2 September 2020

218064

**RE: RESPONSE TO SUBMISSIONS
DARLINGTON PUBLIC SCHOOL REDEVELOPMENT (SSD-9914)**

Figure 1 Amended Student Bicycle and Scooter Parking Layout

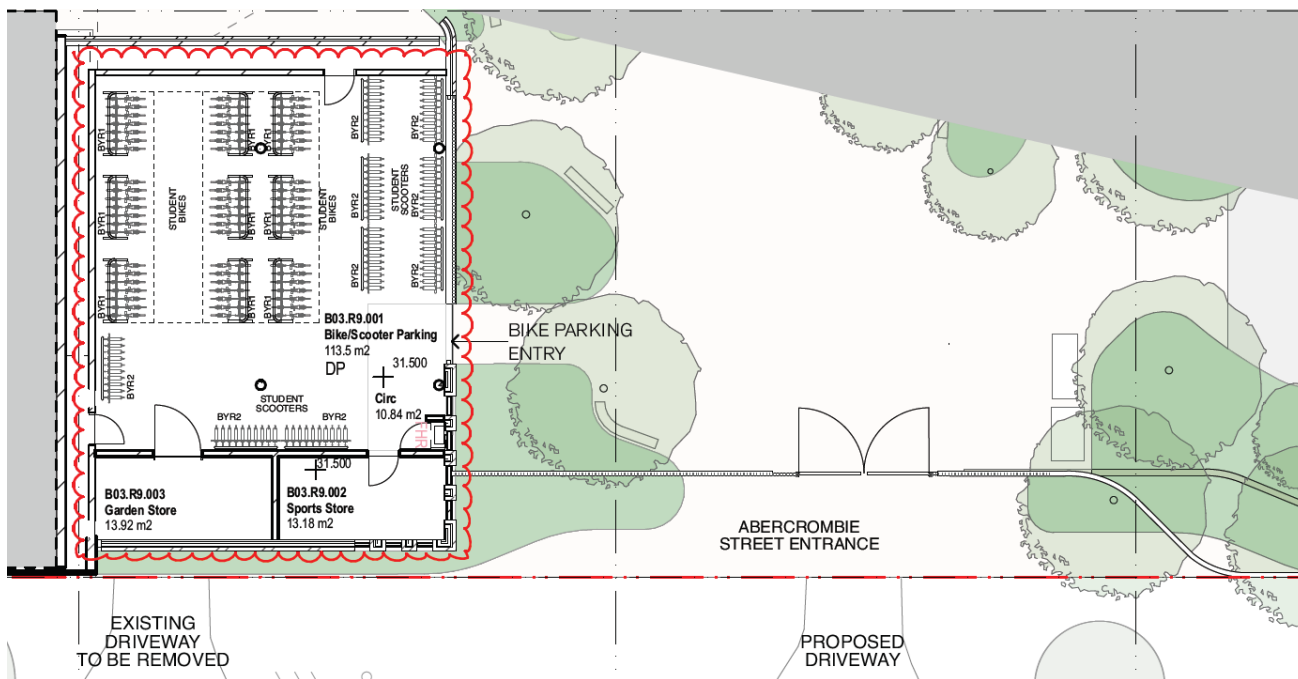
Insufficient bicycle and scooter parking provided for the expected future population of the school.

The amount of student bicycle and scooter parking has been increased from 67 spaces to 145 spaces. This is comprised of 63 bicycle parking spaces and 82 scooter spaces in a single, dedicated storage area adjacent to the Abercrombie Street entrance (**Figure 1**). This equates to 35% of the future student population of the school. Since the target mode share for the future student population is 35% of students riding/scootering to school, as outlined in the Green Travel Plan provided with the EIS (Section 9.0 of Appendix L), the increased provision is sufficient to accommodate the future population of the school, considering the target mode share.
